Mobile Intel[®] Pentium[®] II Processor Specification Update

Release Date: August 2006

Order Number: 243887-054

Figure 1. An Example of Microcontroller Driven Thermal Management

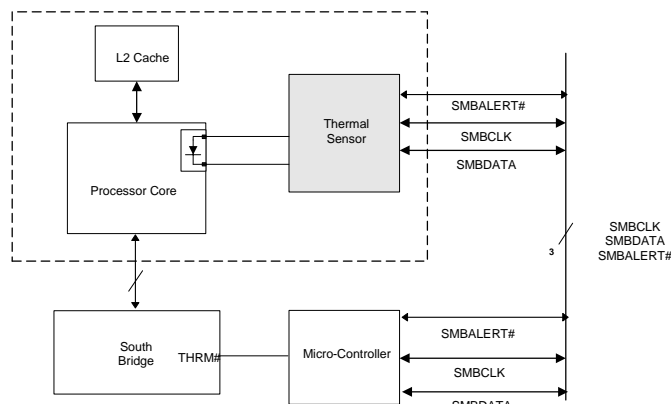
Problem: The Mobile Pentium II processor and the Pentium II Processor Mobile Module have a thermal sensor that monitors the processor core's temperature. Please note that desktop systems could have a similar thermal device. The thermal sensor asserts SMBALERT# if the processor temperature exceeds the temperature limits set in the Alarm Threshold Registers (T_{HIGH} , T_{LOW}). It also sets the corresponding Status Register bits to identify the cause of the interrupt. Figure 1 gives one example of the how the SMBALERT# signal could be used in a system.

Figure 2. Workaround Flowchart: SMBALERT#-Driven System

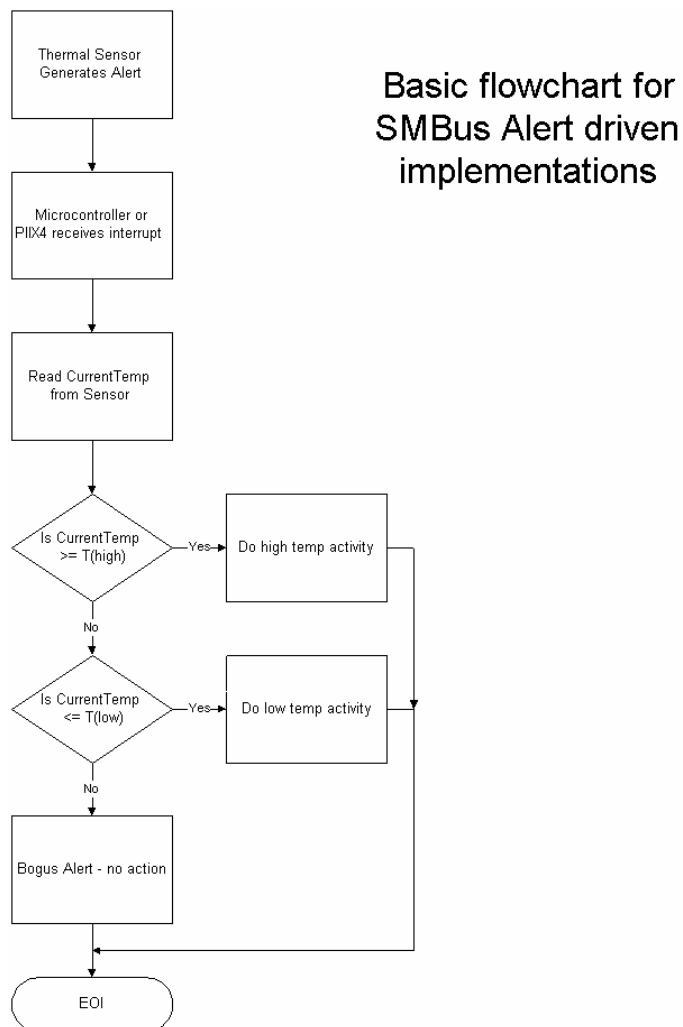
Under the conditions described below, the thermal sensor incorrectly generates the SMBALERT# interrupt. All of the following conditions must be met to trigger a false interrupt:

1. Before servicing an interrupt from the thermal sensor, read and compare the processor thermal reading with the threshold limits (T_{HIGH} or T_{LOW}). Figures 2 and 3 provide basic flowcharts for the implementation of this workaround in an interrupt driven system.
2. If the firmware implemented polls the Status Register only, then before taking any action, re-read the temperature register and do a comparison with the alarm threshold limits (T_{HIGH} or T_{LOW}) to determine if the value is actually still within the temperature window.

3. Use a temperature polling scheme to monitor the processor temperature.

Figure 1. TAP Gageable Thread Clarification

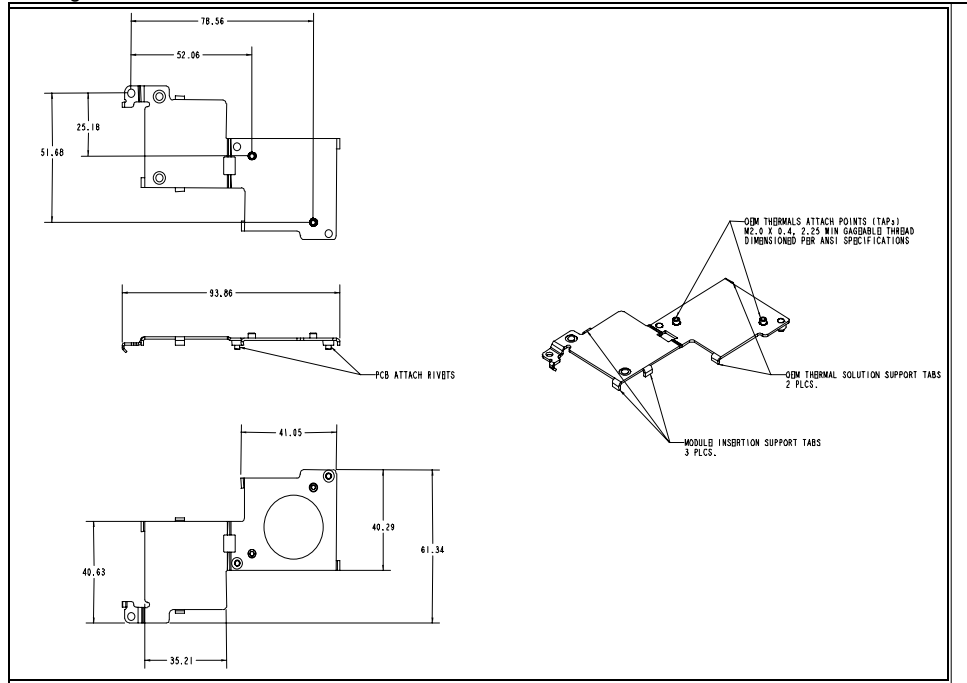
In the *Intel® Pentium® II Processor Mobile Module : Mobile Module Connector 1 (MMC-1)* and the *Intel® Pentium® II Processor Mobile Module : Mobile Module Connector 2 (MMC-2)* datasheets (Order Numbers 243667 and 243668, respectively), the thermal attach point (TAP) gageable thread specification was not clearly identified in Figure 14, of Section 5.2. The following is the TAP clarification:

OEM Thermal Attach Points (TAPs) M2.0 x 0.4, 2.25 min gageable thread dimensioned per ANSI specification.

See Figure 1 below for more information.
